ADDENDUM

JLG 24146.01-5 Dunn County Public Safety Center

Issued: November 7, 2025

ADDENDUM #: 02

5E EXAM ROOM A205 - WEST
SCALE: 1/4" = 1'-0"

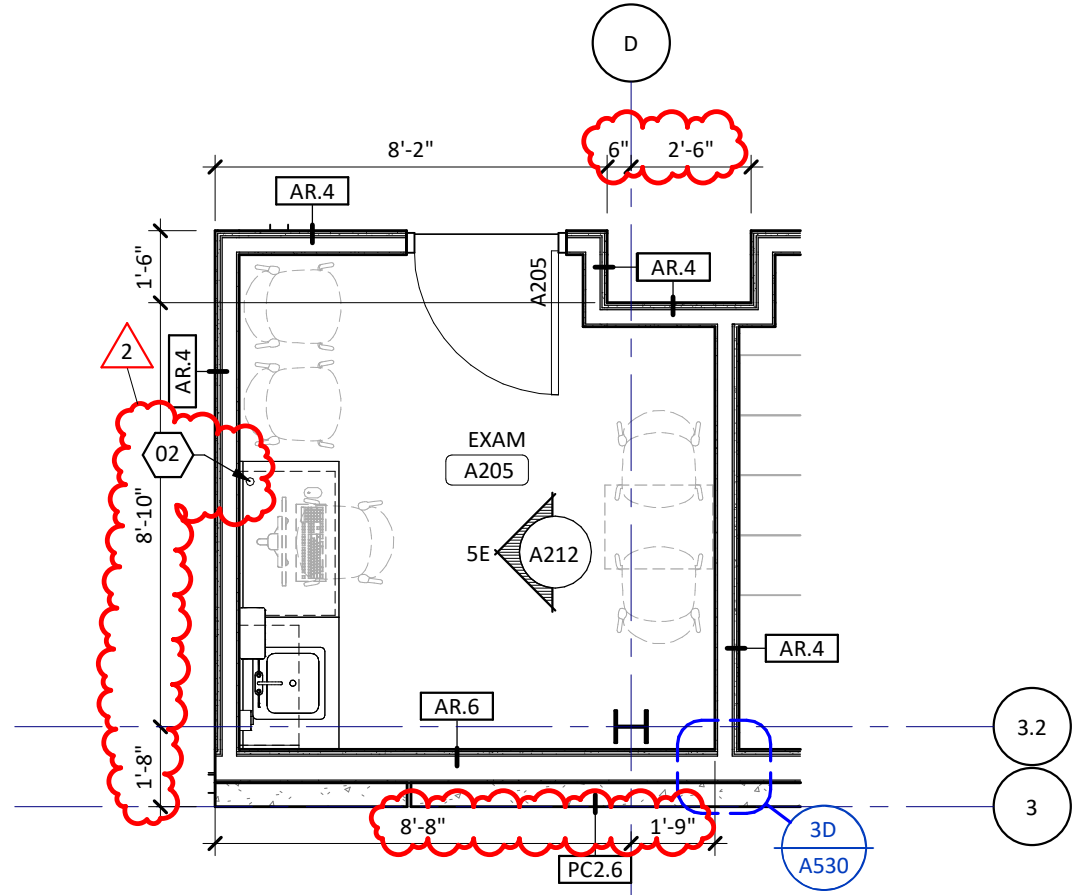
- o Turned on grids and updated dimensions.
 - o Drawing 1E & 5E: Add electric hand dryer (HAND DRY-1) as shown in plan and elevation.
 - o Drawing 3D & 3E: Revise shower note to read “Fiberglass shower surround, see plumbing”. Add material id tag on grab bar as shown.

4B BREAK ROOM A122 - ENLARGED PLAN
SCALE: 1/4" = 1'-0"

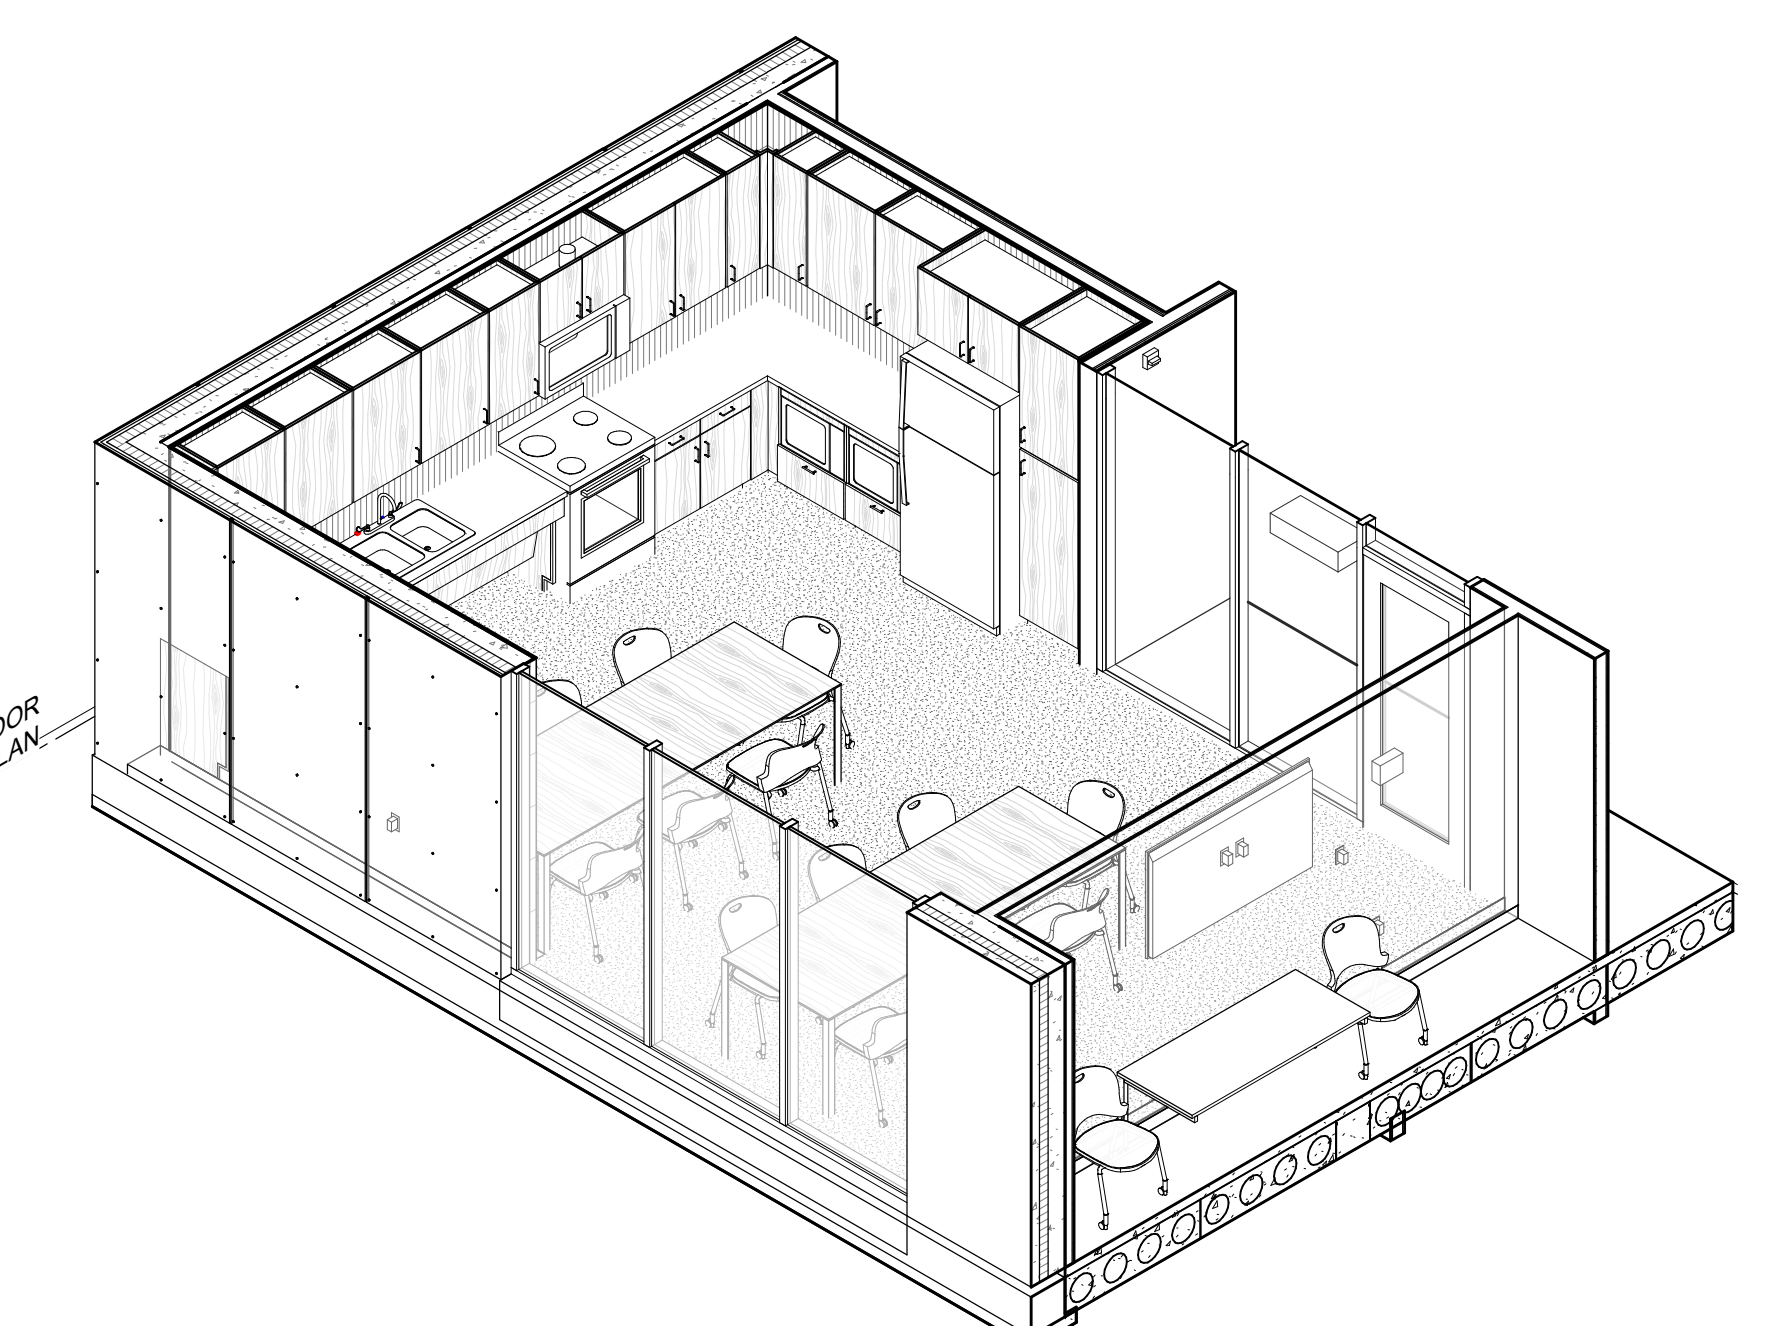
- o Drawing 4B: Revise sink to a two basin sink in lieu of a single basin sink as shown, see plumbing drawings for more information.
 - o Drawing 4E: Add grommet and keynote 02 to desk as shown.

4A
A214
BREAK ROOM A213 - ENLARGED PLAN
SCALE: 1/4" = 1'-0"

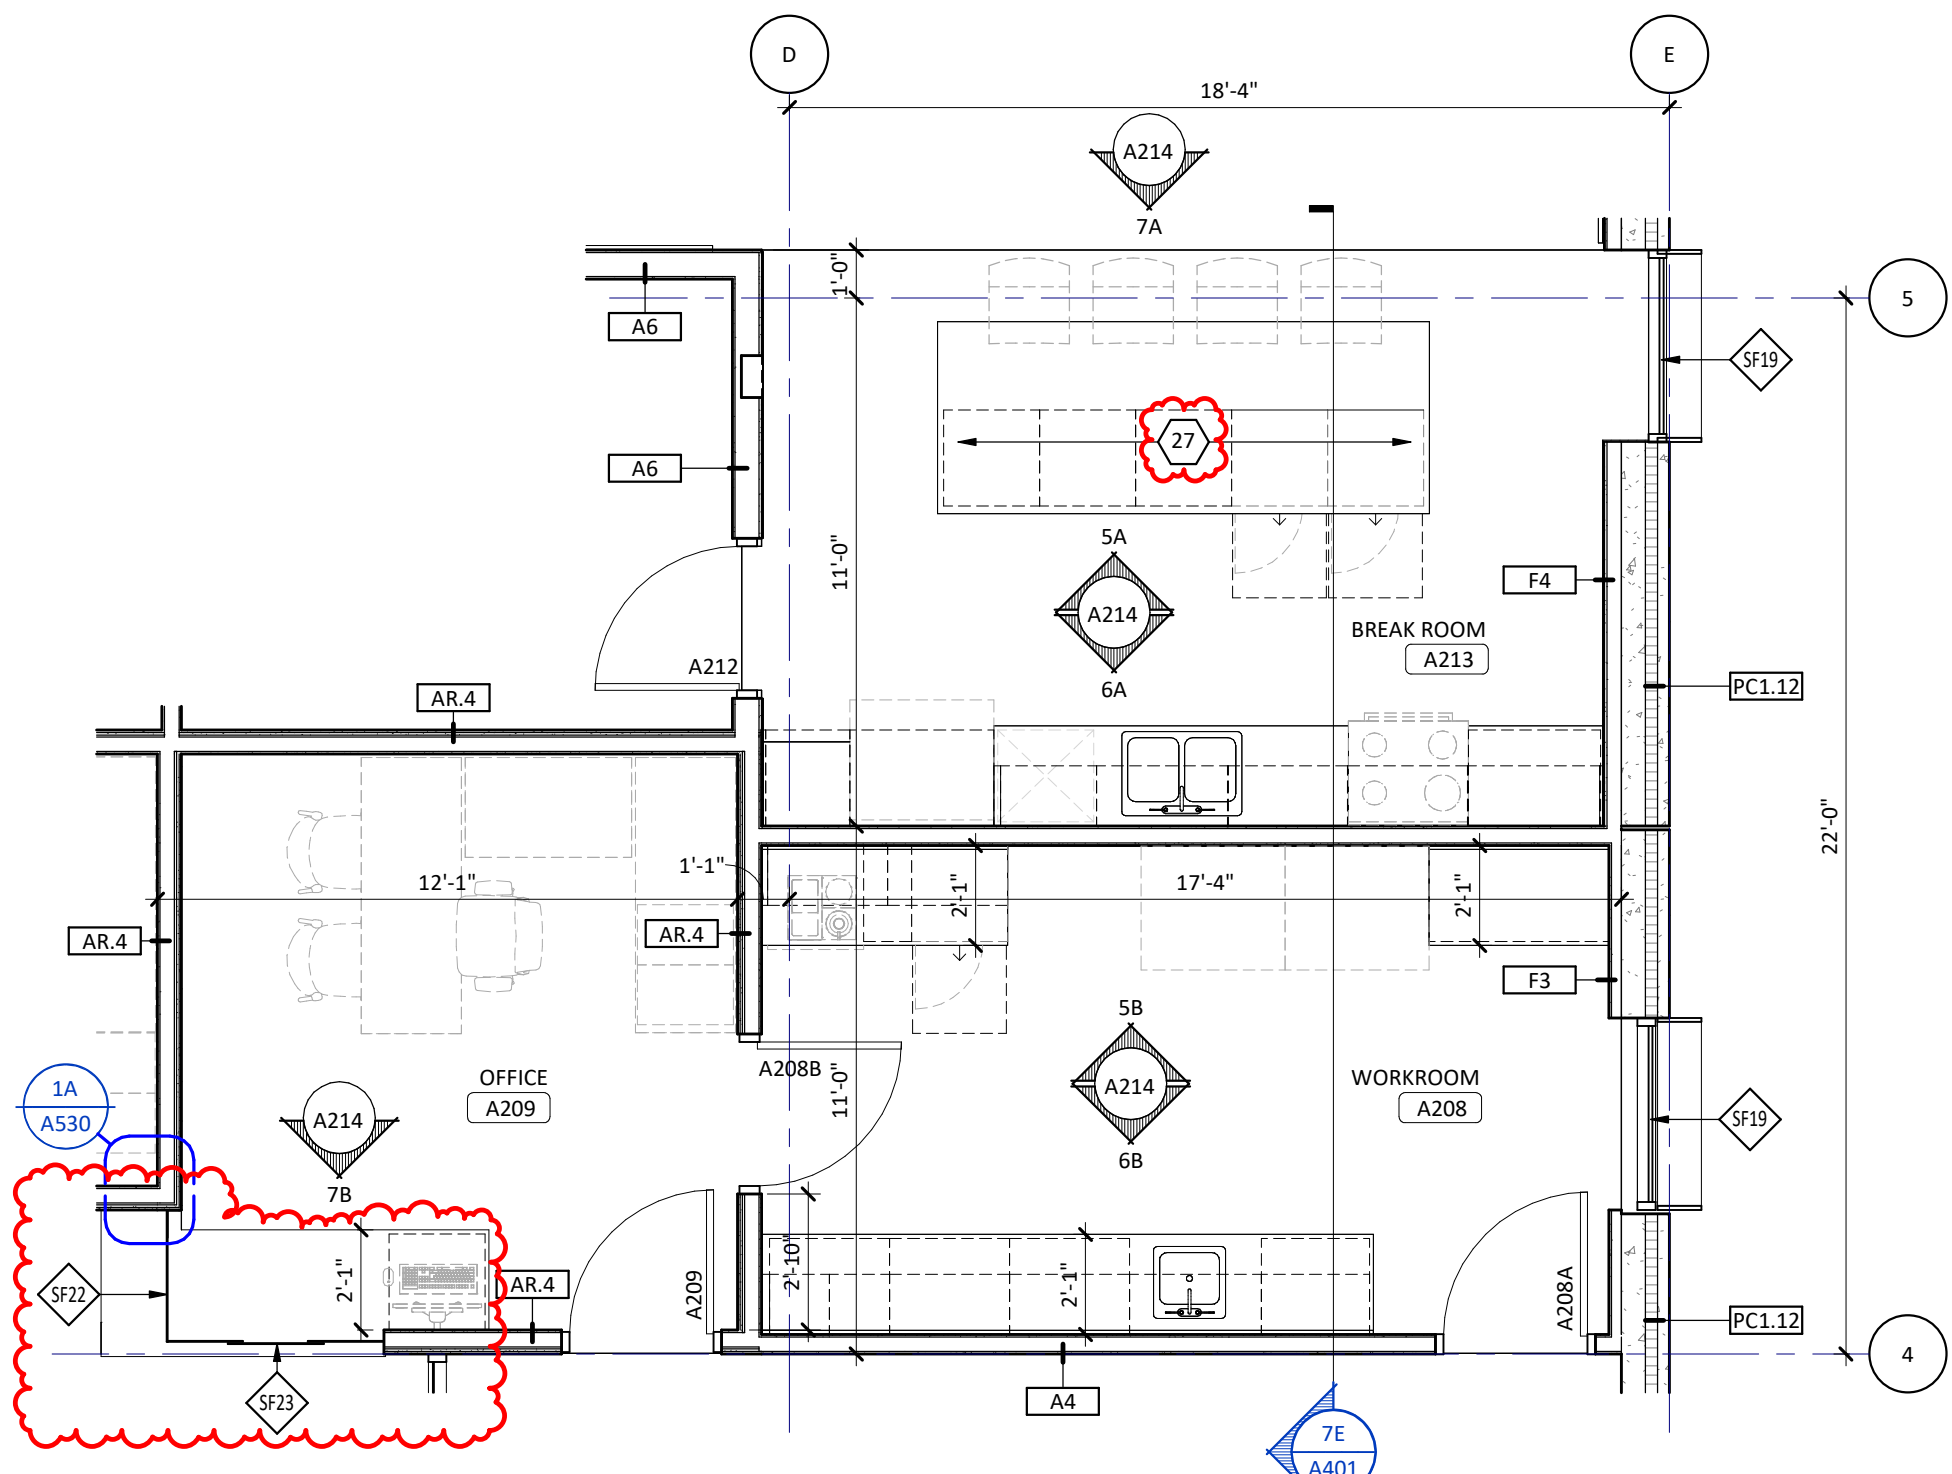
- o Turned on grids and updated dimensions.
 - o Drawing 4A:
 - Add keynote 27 at Break Room A213 island.
 - Revise Office A209 reception desk as shown.
 - o Keynotes – Floor Plan: Add keynote 27 to read: “Counter mount pop-up style power receptacle, see electrical. Verify location with architect.”

5C SF22 - INTERIOR
SCALE: 1/4" = 1'-0"

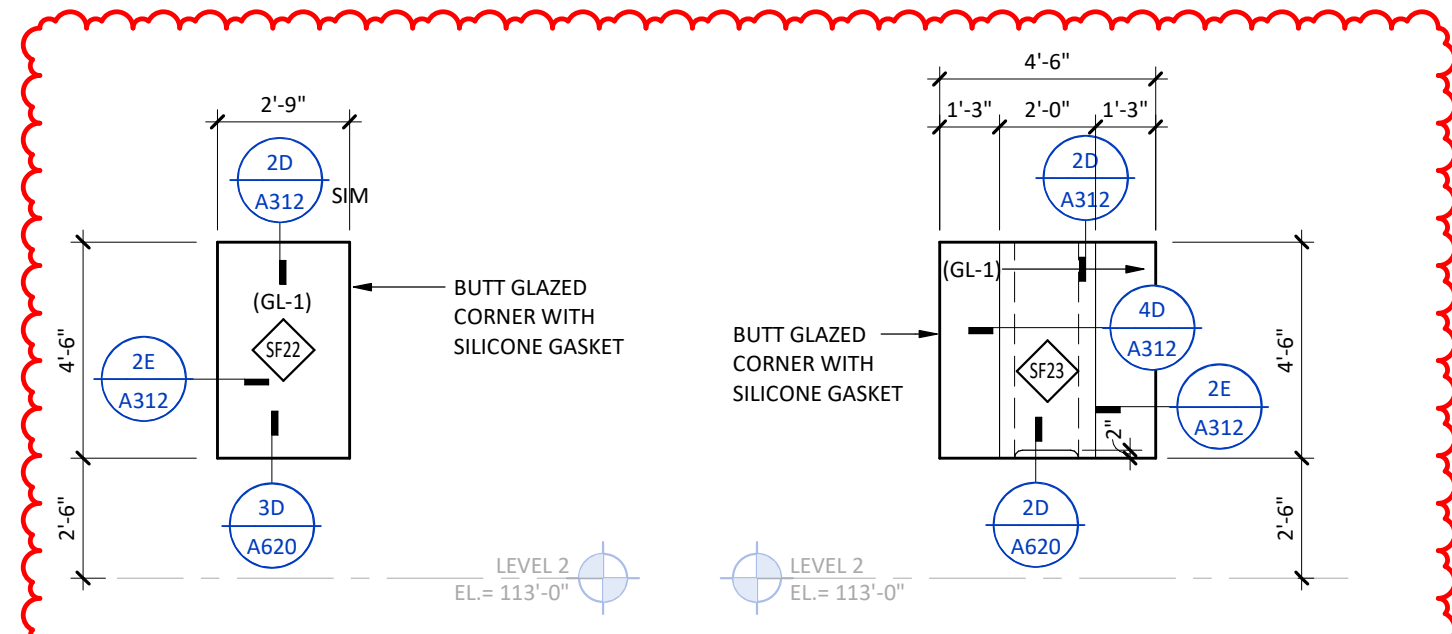
- o Replace sheet in its entirety.
- o Drawing 9A: Remove SF1 drawing in its entirety.
- o Drawing 4B & 5B: Revise Sherif reception glazing SF13 and SF14 as shown.
- o Drawing 4C & 5C: Revise Public Health reception glazing SF22 and SF23 as shown.

1
E100
Site Plan
1" = 20'-0"

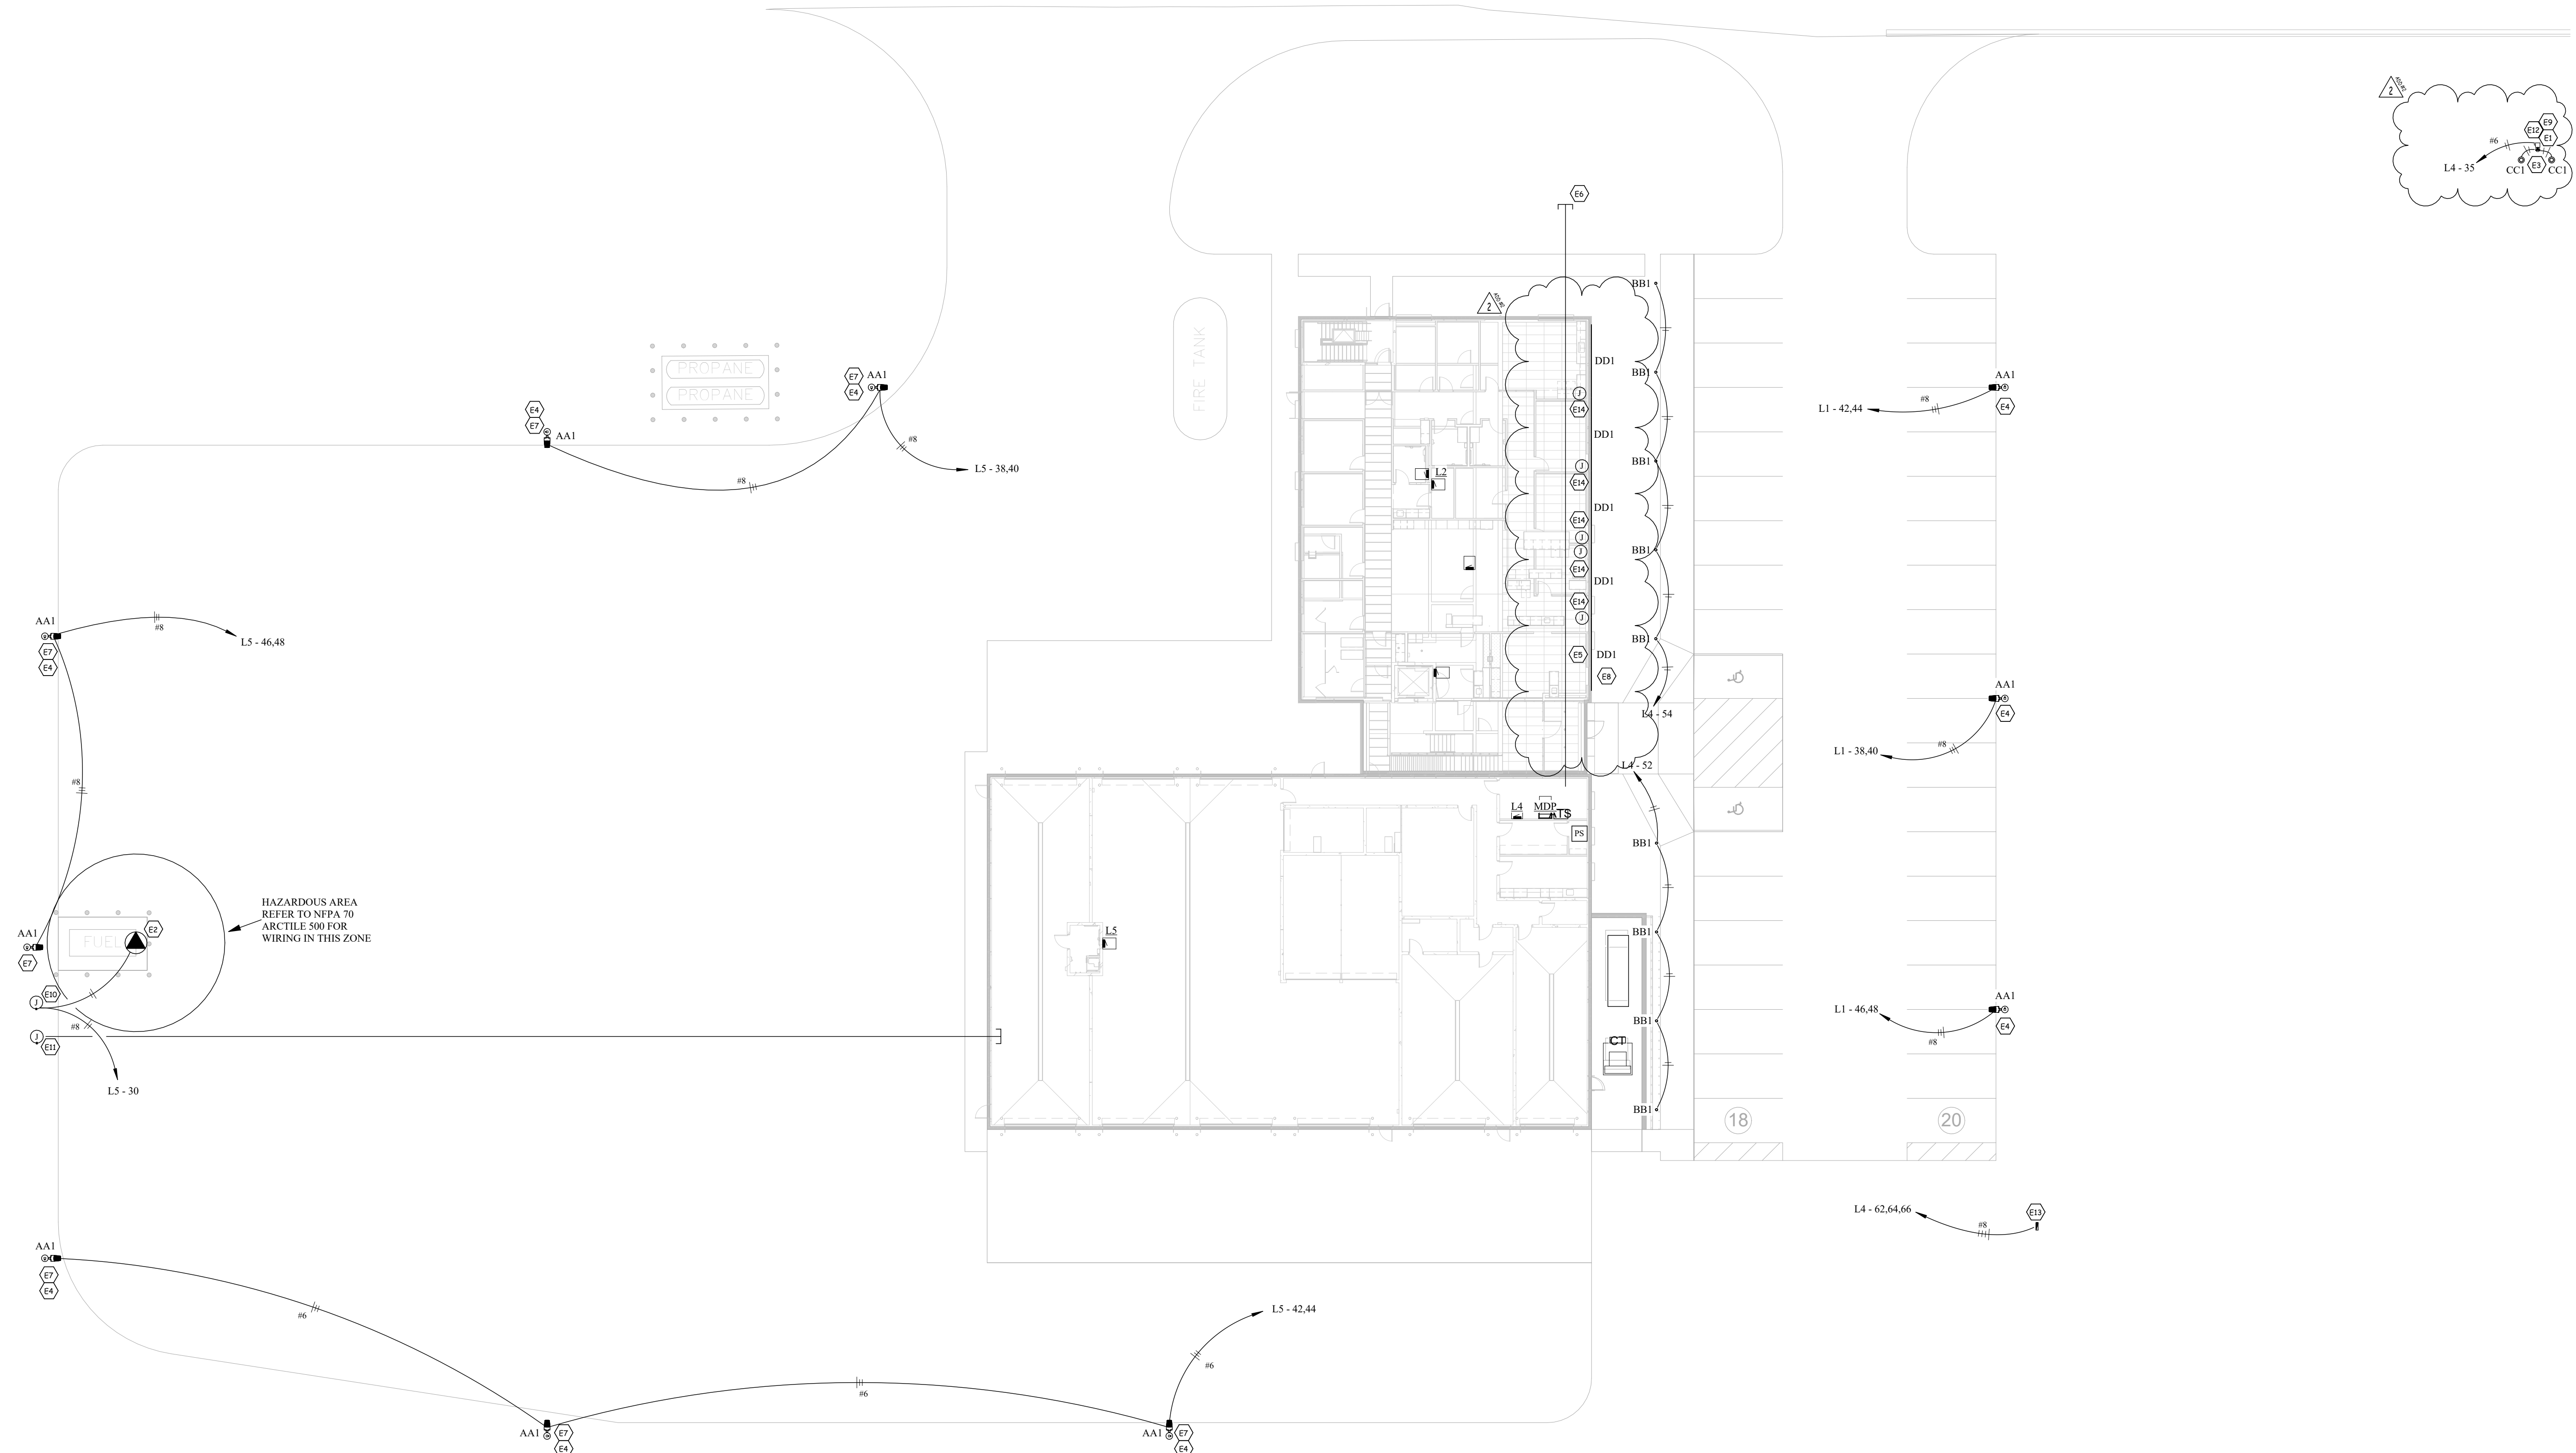
1. E100 – SITE PLAN
 - o Drawing 1/E100: Added Type DD1 fixtures, and added keynotes.
2. E201 – LEVEL 1 LIGHTING PLAN
 - o Drawing 1/E201: Added additional Type U1 fixtures, lighting control locations, and added keynotes.
3. E203 – LIGHTING DETAIL
 - o Detail 3/E203: Updated for flagpole light fixture use.
4. E300 – BASEMENT POWER PLAN
 - o Drawing 1/E300: Updated equipment DP-1 and DP-2 to include disconnects and match mechanical. Added HUH-1, 2, 3, and SP-4.
5. E301 – LEVEL 1 POWER PLAN
 - o Drawing 1/E301: Updated Room A114 water control to be by solenoid rather than electric flush valve and updated keynote.
6. E302 – LEVEL 2 POWER PLAN
 - o Drawing 1/E302: Revised P-8 to be P-6 to match mechanical.
